URBAN DESIGN COMMISSION APPLICATION

Title: Madison Yards at Hill Farms

RE: UDC Initial Approval Conditions Response - Madison Yards at Hill Farms, Urban Design Commission Application

UDC SUPPLEMENTAL MATERIAL EXHIBIT B

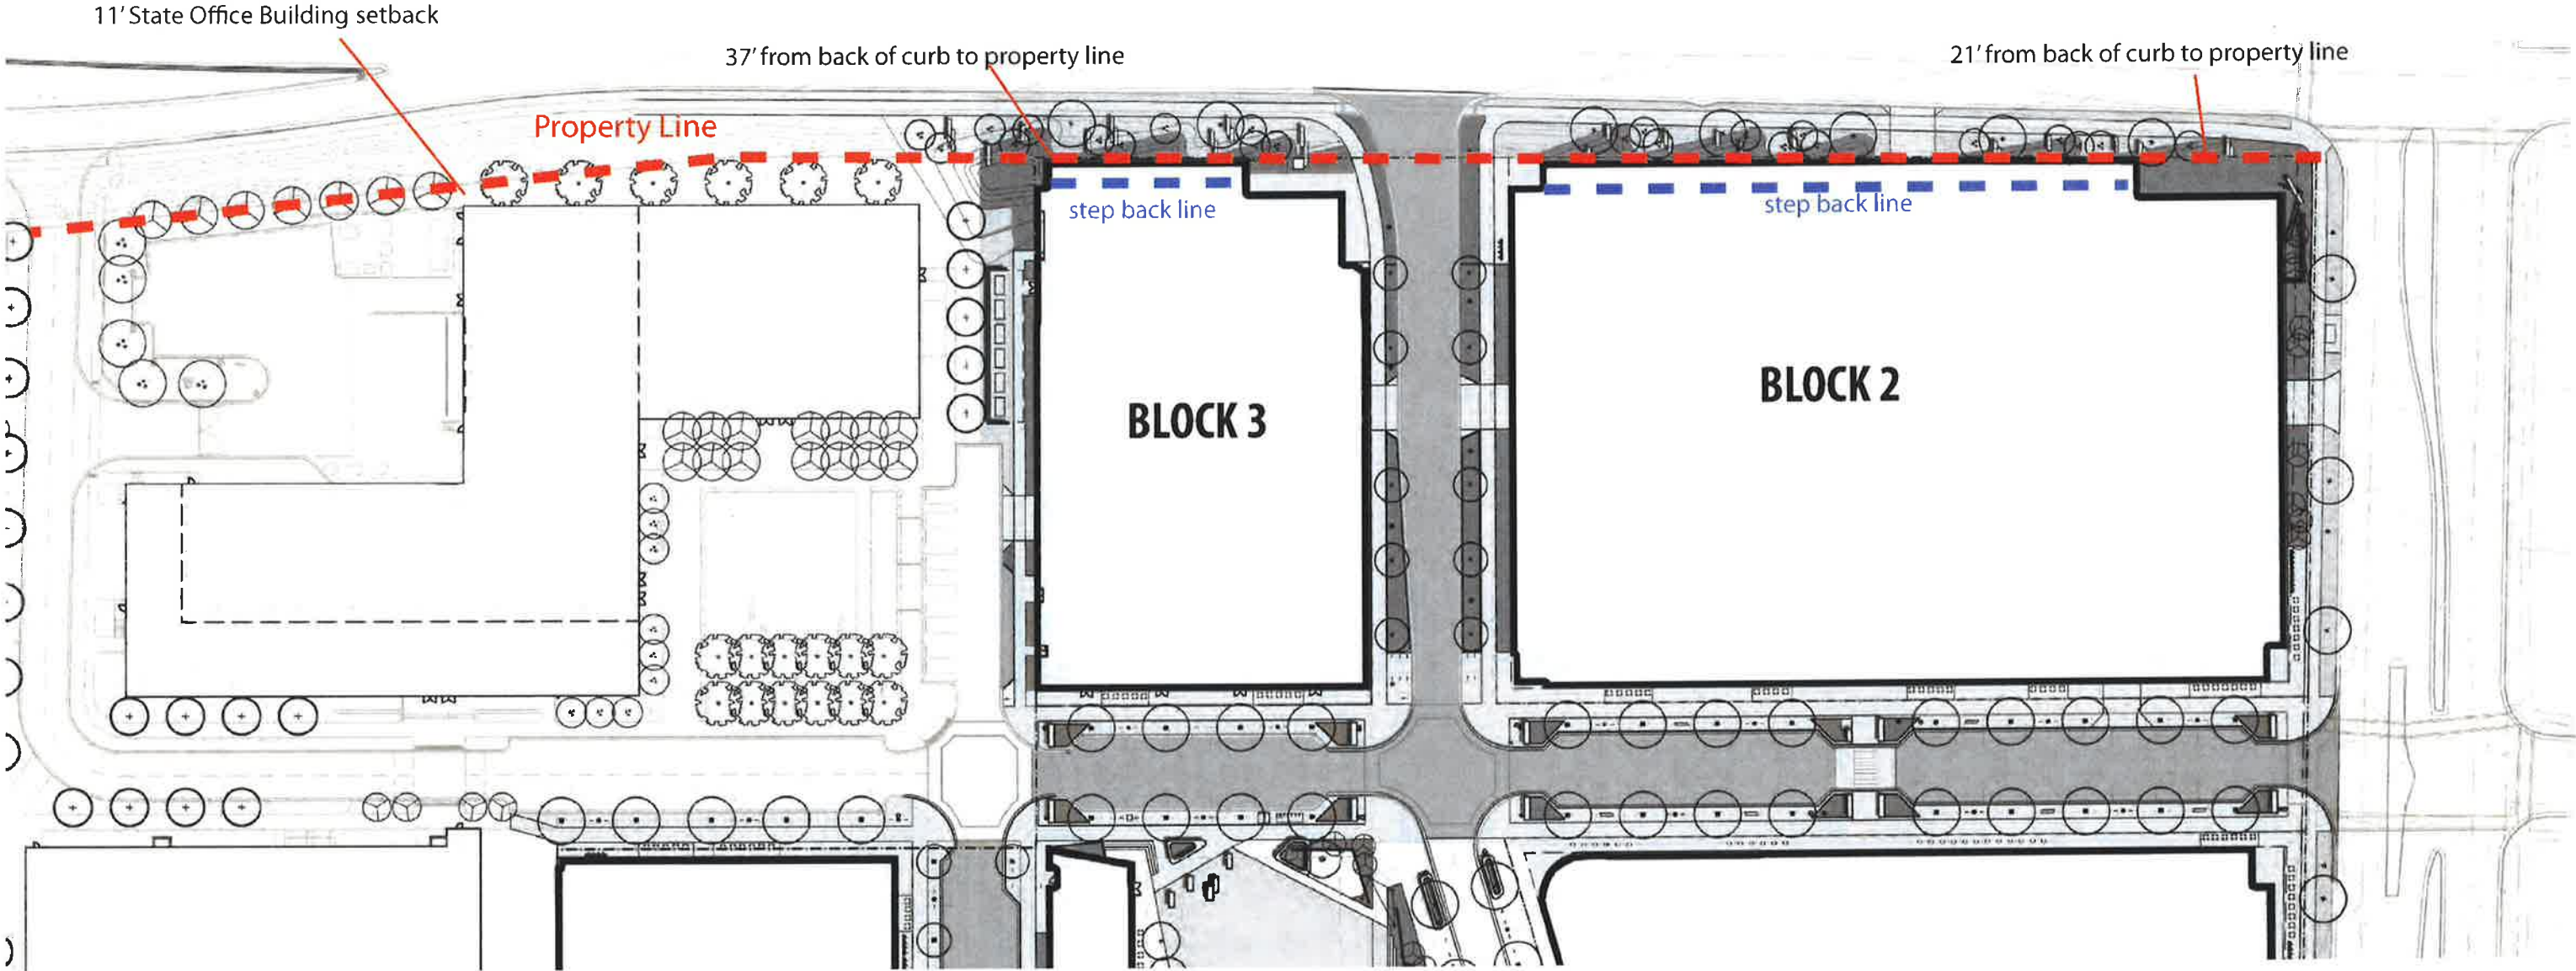
2. More information on the permitted materials.

Common Council's conditional approval includes the following requirement from City Staff:
"Include a building materials palette or refer specifically to the materials palette for Mixed-Use and Commercial Districts in Section 28.060(g) of the Zoning Code"

- i. Terra Cotta panels will be allowed per the requirements of Fiber Cement Siding/Panels*
- ii. High Pressure Laminate panels will be allowed per the requirements of Fiber Cement Siding/Panels*

Table 28D-1 of section 28.060 is included in the attached *UDC Supplemental Material Exhibit A*. We are requesting the addition of high pressure laminate (HPL) and terra cotta to the allowable materials palette. Example images for HPL and terra cotta are shown on the attached *UDC Supplemental Material Exhibit B*.

UDC SUPPLEMENTAL MATERIAL EXHIBIT C-2

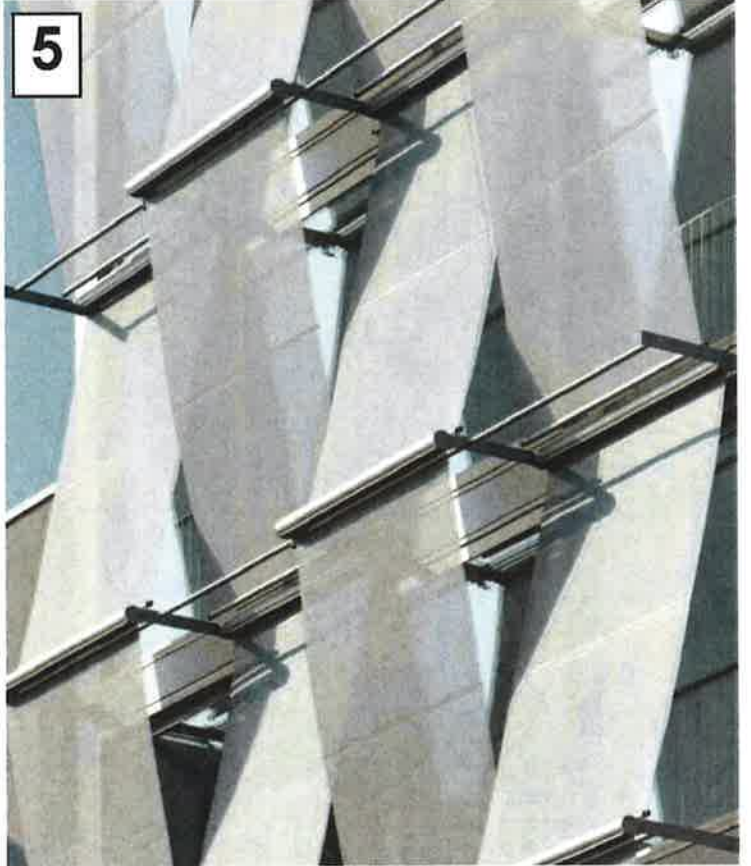
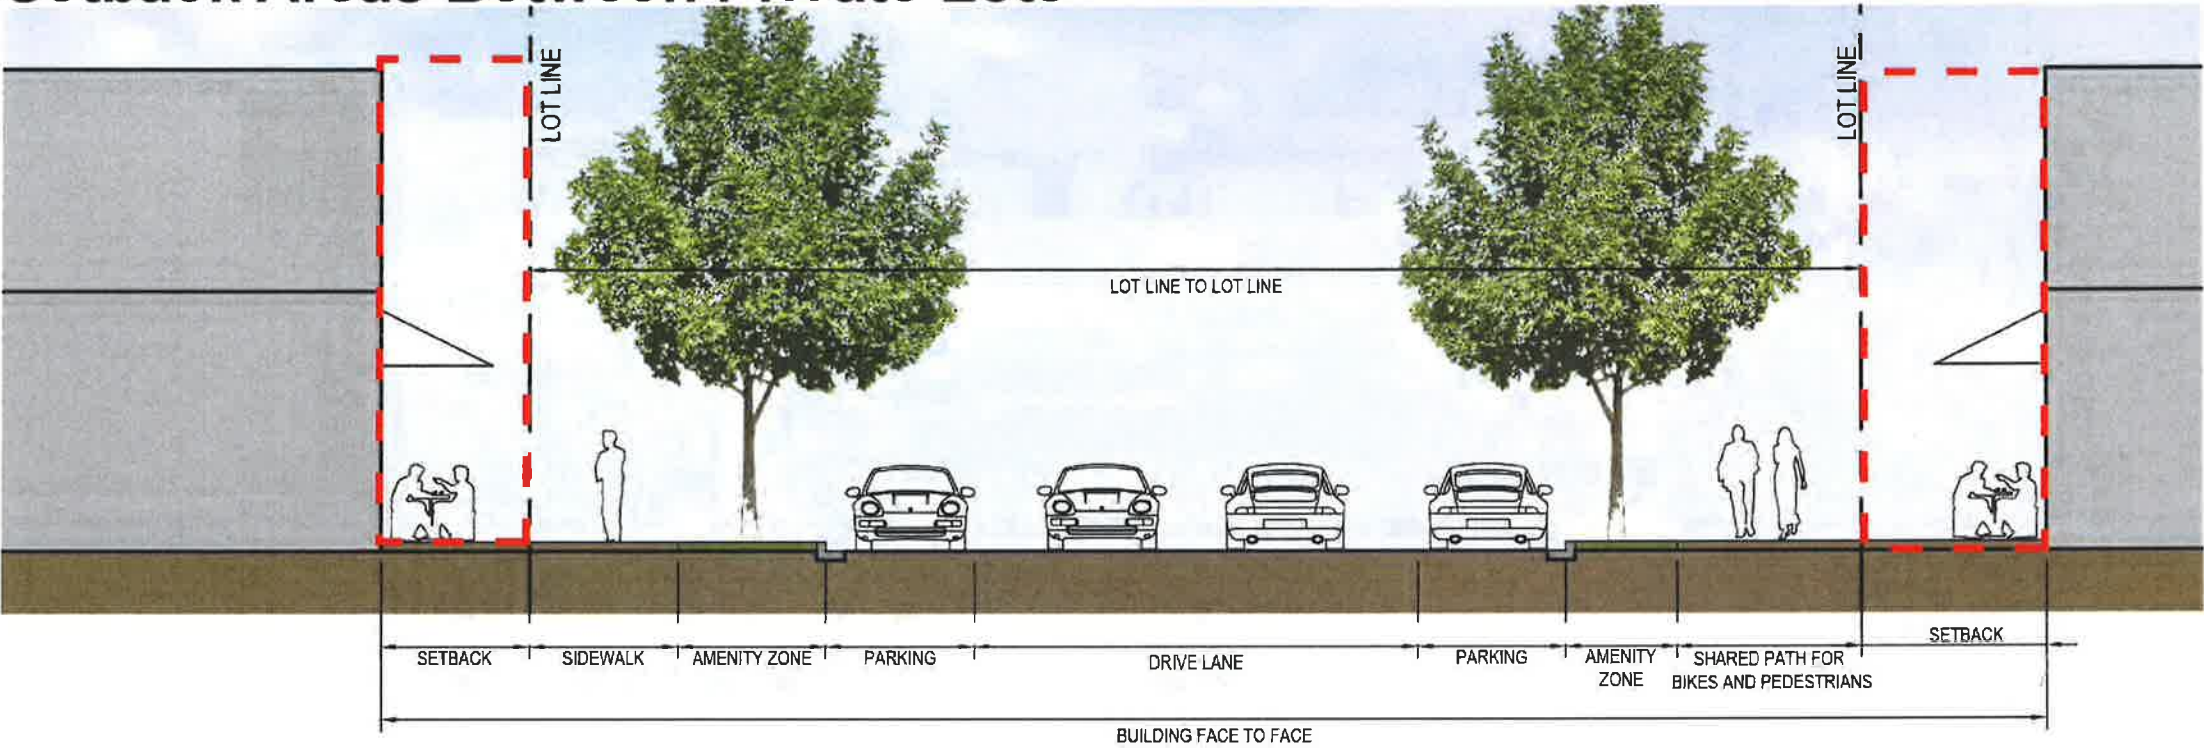
3. Look at the setback along University Avenue to match the DOT building.

The Madison Yards PD/GDP zoning text as approved by Planning Commission and Common Council allows for a 0' setback on University Avenue for up to 80% of the building façade for Blocks 2 and 3. In addition, the majority of the façade on upper floors along University Avenue are required to be setback 10' from the property line. The zoning text is consistent with a dense, urban mixed-use development and the adjacent development along University Ave, and Segoe Road in the Hilldale PD District as shown in the attached *UDC Supplemental Material Exhibit C-1, C-2 & C-3*.

The ROW is unusually large along the north boundary of the project on University Avenue and the Development team is proposing a landscaped buffer area between the 0' setback area and the existing sidewalk. As noted in the Planning Division Staff Report dated 4/23/18, City Planning Staff has confirmed that the existing ROW along University Ave would allow for future road expansion without eliminated the landscape buffer between the sidewalk and the portion of the buildings with a 0' setback.
